# SENENICH PROPELLER CO., INC.

## FAQ FOR SERVICE BULLETIN SB2016-06B

Service Bulletin [SB2016-06B](#) contains all the definitive information for model and serial number applicability. This FAQ provides supplemental information to illustrate the following: model and serial number identification, previous service bulletins, hub model progression and pitch system variations, crack location and inspection recommendations, blade retention redundancy, and options available for compliance with the service bulletin.

Figure 1. Hub Model 2A0 Series Revision "D" and earlier

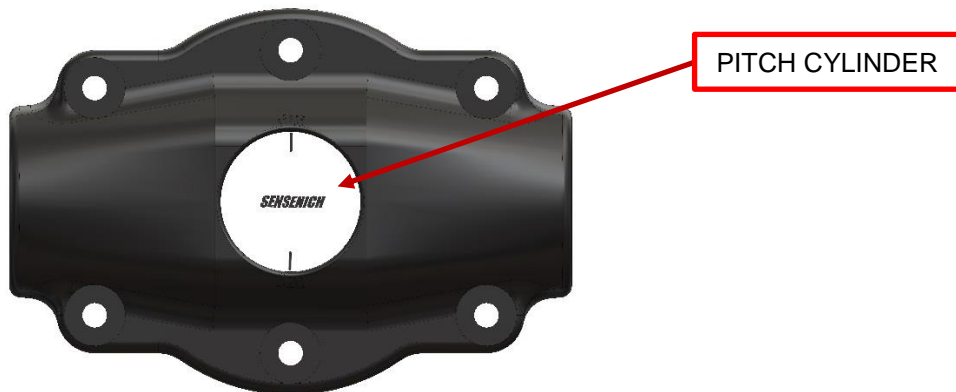
Models 2A0J5 and 2A0R5, revision "0", "A", "B", "C", and "D".

See Figure 1.

The first several years of hub production did not include a stamped model number on the part.

*Identification is denoted by the presence of the white pitch cylinder.*

The hub serial number is stamped on each hub half, either on the side or on the inside surface on one side of the blade shank cavity.

The serial number last digit indicates the revision level: If the last digit is a number, then it is revision "0", otherwise there is a letter such as "A", "B", etc...

Revision "D" was the last hub revision which incorporated the pitch cylinder feature.

Figure 2. Hub Model 2A0 series Revision "E" and later

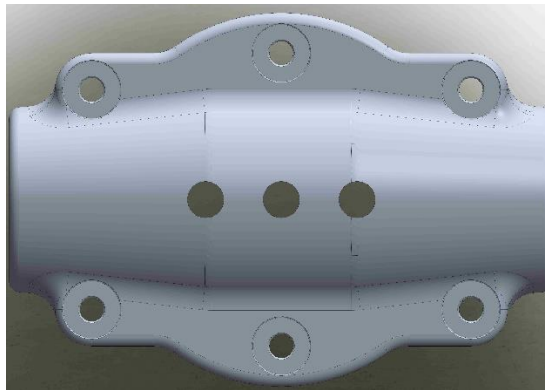
- Revision "E" or later 2A0 series hubs with three ½" diameter holes in the hub cover half are not affected. See Figure 2.

Figure 3. Hub Models 2A1R5 and 3A0B7, respectively

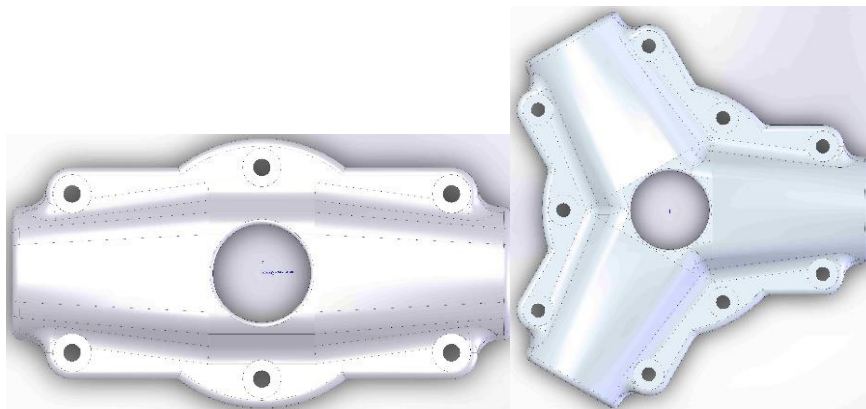
- Model 2A1R5 and 3A0B7 hubs with long blade shanks are not affected. While they do incorporate the white pitch cylinder, the blade retention geometry is significantly longer and different from the compact 2A0 series so that this service bulletin does not apply. See Figure 3.

Figure 4. Cracks start near pitch marks and grow outwards. Inspection inside the hub cover is required.

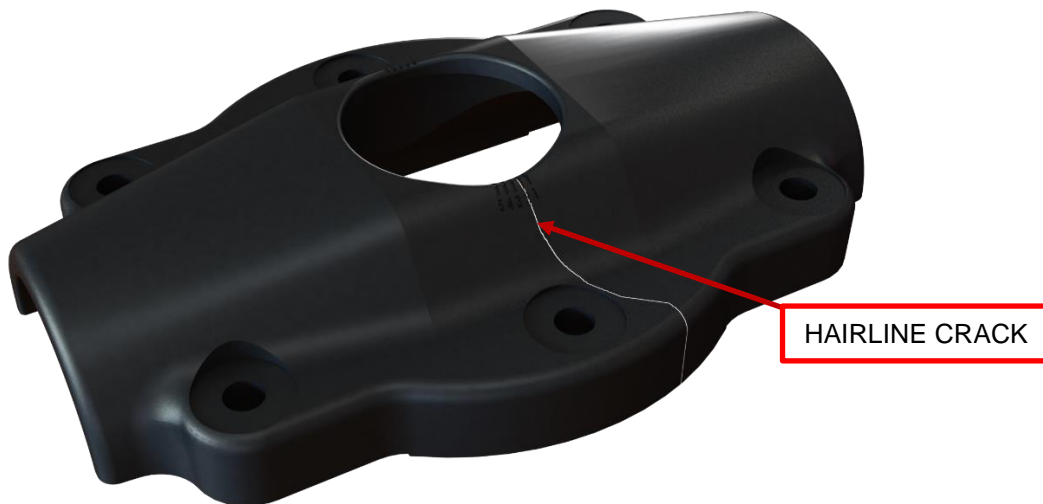
- The hub cracks typically start at or near the pitch marks on the sides of the central hole, and grow outwards towards the hub sides. They are hairline cracks which are very difficult to see with the naked eye. We recommend using very good lighting, a 10x magnifying glass and inspecting the inside of the pitch cylinder hole in the hub cover next to the pitch marks.
- See Figures 4 through 6 below. Figure 4 shows the best location for inspection, on the inside of the hub cover pitch cylinder hole.
- The hub cover must be removed from the propeller assembly for thorough inspection inside the pitch cylinder hole. *Inspection of the hub exterior is not adequate.*
- Hub color/plating does not appear to be a factor, but the black anodize makes inspection more difficult.
- This inspection must be performed every 50 flight hours or annually, whichever comes first.

Figure 5. Unattended cracks may progress to edges of hub cover half.

Figure 6. Nord-Lock Lock Washer

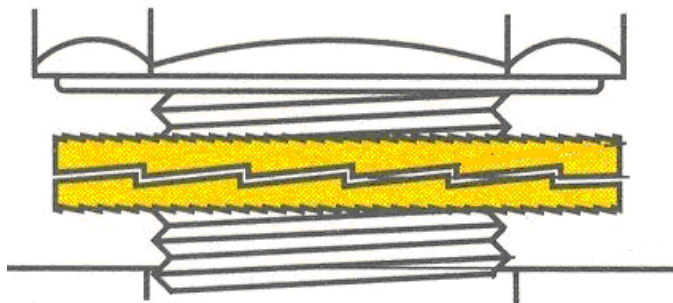
Nord-lock washers work in pairs with the ramped sides facing each other. See Figure 6.

During loosening, the Nord-lock washers may click loudly; this is normal. Inspect Nord-lock washers on the inside cam surfaces and outside serrations. Replace washers with excessive wear.

Lubricate acceptable washers with a light coating of engine oil or equivalent.

Figure 6. Clamp Bushing Engagement into Hub Cover

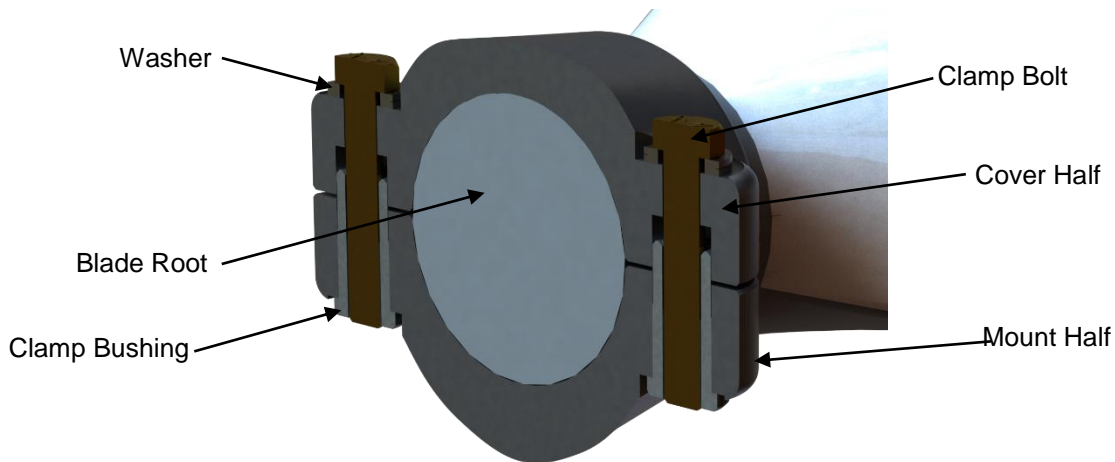
One design element which increases the retention safety for the 2A0 hub series is the incorporation of threaded clamp bushings. These bushings are press fit in the hub mount half and engage the hub cover half when the propeller blades are pitched and clamp bolts fully torqued. This ensures that the propeller clamp bolts do not carry any shear loads even if the hub cover cracks into two pieces.

See Figure 6.

NOTE: The clamp bushings provide blade retention backup *and do not change the 50 hour inspection interval for this service bulletin.*
